ADDENDUM NO. 2

REBID OF
Install Nature Park
Missouri School for the Blind
St. Louis, Missouri
PROJECT NO. E1703-01

Bidders are hereby informed that the Construction Plans and/or Specifications are modified as follows:

2 SYNTHETIC TURF BASE CONSTRUCTION
C-403 SCALE: NO SCALE

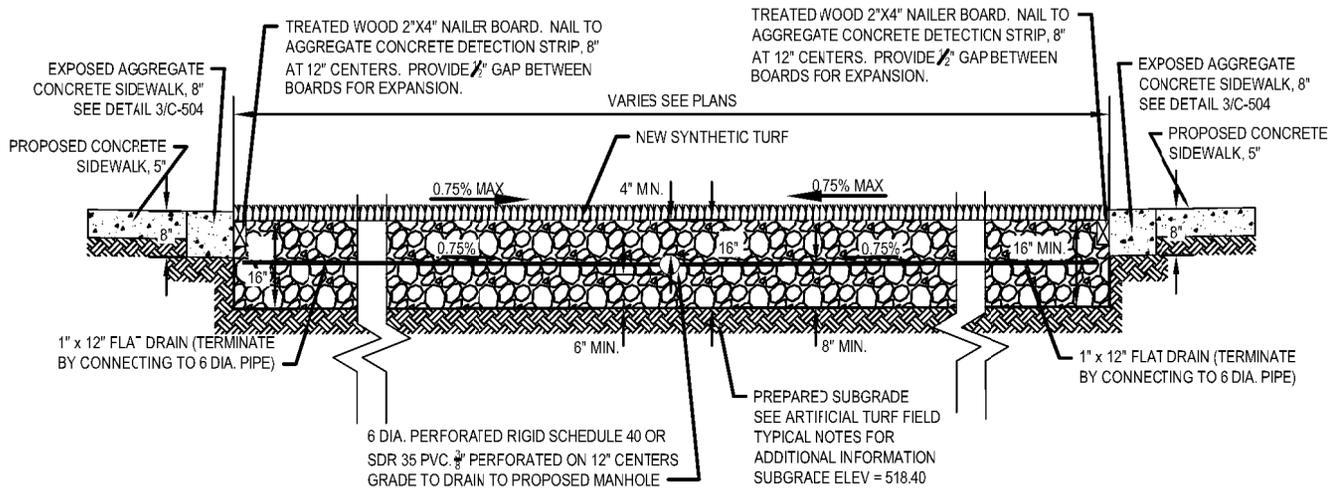
- a. REMOVE AND REPLACE Detail 2/C-403 (see attached).
- b. REMOVE AND REPLACE Detail 3/C-403 (see attached).

NO SOIL COMPACTION IS ALLOWED OR DETENTION AND/OR WATER QUALITY BMP'S WILL BE REQUIRED.

NO LIME STABILIZATION IS ALLOWED OR DETENTION AND/OR WATER QUALITY BMP'S WILL BE REQUIRED.

IF UNSUITABLE SOIL IS REMOVED THEN A CLEAN, UNIFORM GRADATION OF ROCK SHALL BE USED AS FILL.

AN AS-BUILT CERTIFICATION, SIGNED BY THE DESIGN ENGINEER, STATING THAT NO LIME STABILIZATION WAS USED, NO SOIL COMPACTION WAS DONE, AND CLEAN ROCK WAS USED TO REPLACE UNSUITABLE SOIL IN THE TURF FIELD.
